**Pinnacle Mountain State Park**  
Existing Visitor Center Assessment  
Little Rock, Arkansas

August 7, 2023  
Revised October 12, 2023

Summary	Page 2
Diagram of Existing Layout	Page 4
Existing Conditions	Page 5
Renovation Options with Cost Options	Page 26
Initial Review Comments + Responses	Page 35

**Option 2 - Version B** shows kitchen located where current meeting room is, allowing exhibit hall (which higher ceilings) to be used as multi-purpose/meeting space. This option is located over the crawl space.

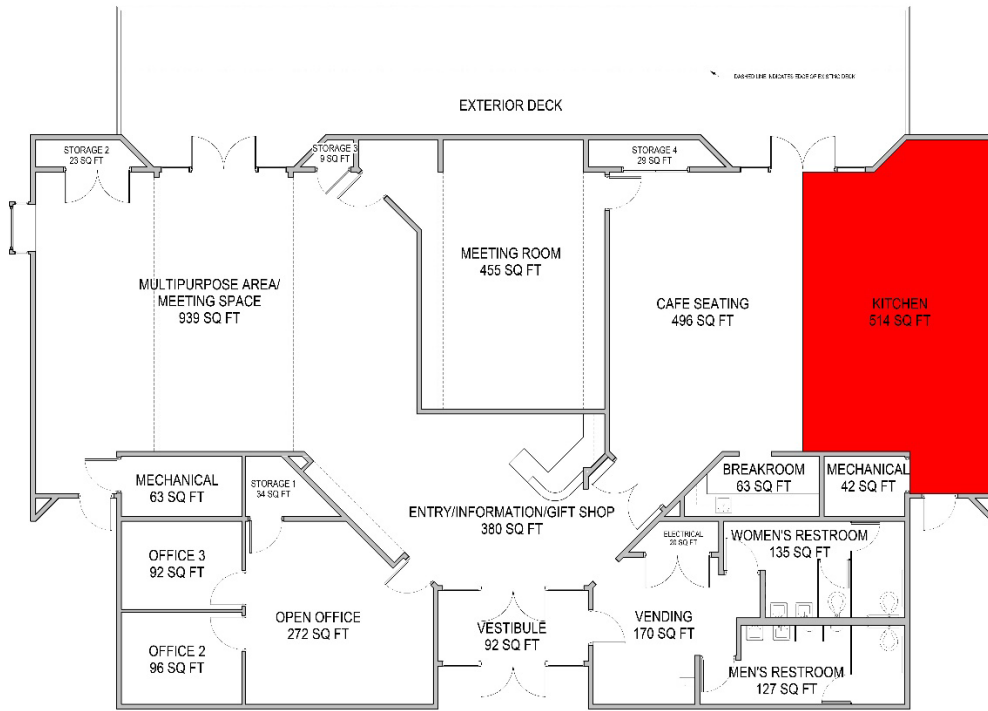
9. Park management feels that Option 1 would be the best option and less labor intensive on the staff's part.
10. Andrew felt that with the Option 2 (p. 29) red area on the far right (where the current meeting room is located), might be a better location for a catering kitchen for plumbing access under the floor. However, on the attached marked-up sheet, we were thinking the center area might be a better location if plumbing would still work for that location as shown on the attached marked-up sheet. **We can provide a diagram that shows this option. (included in revisions 10/12/2023)**

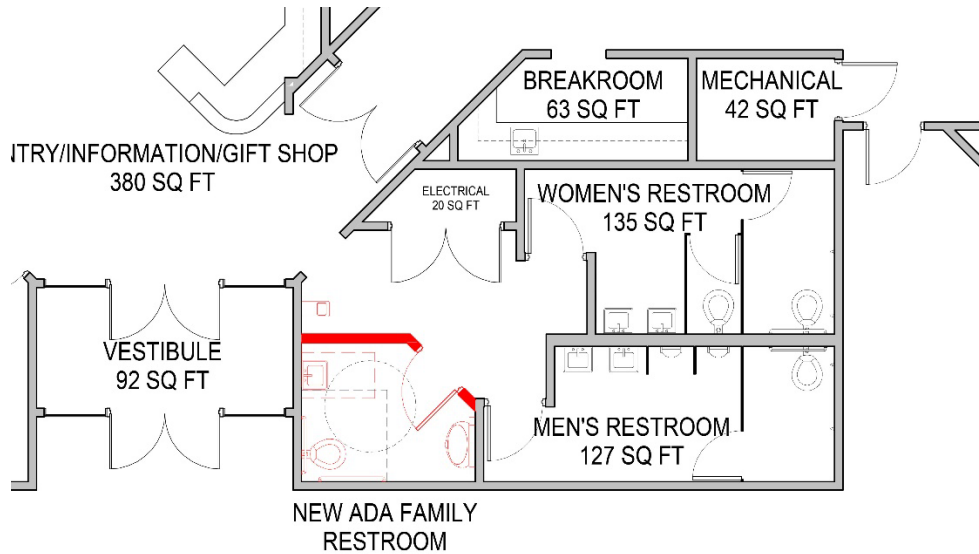
12. We could leave the two offices in their current location (Supt & Asst Supt) and use the other open space for changing rooms for wedding guests using the facility. Perhaps the Family restroom could go into the restroom area where the current vending machine is located, and plumbing is nearby. Noted; will update pricing to include additional restroom and revisions. (included in revisions 10/12/2023)
13. We would like to expand the back deck to twice the width and would consider some roof overhang to protect visitors from rain. Option 2 lists two options for expanding the deck to approximately twice the current width. Option 3 lists an additional structure for covering a portion of the deck. These items have been listed separately so that they could be added to any of the pricing options.

This additional ADA Family restroom layout could be added to any of the options above. The current drinking fountain will be relocated. Area is on slab foundation and would require trenching.
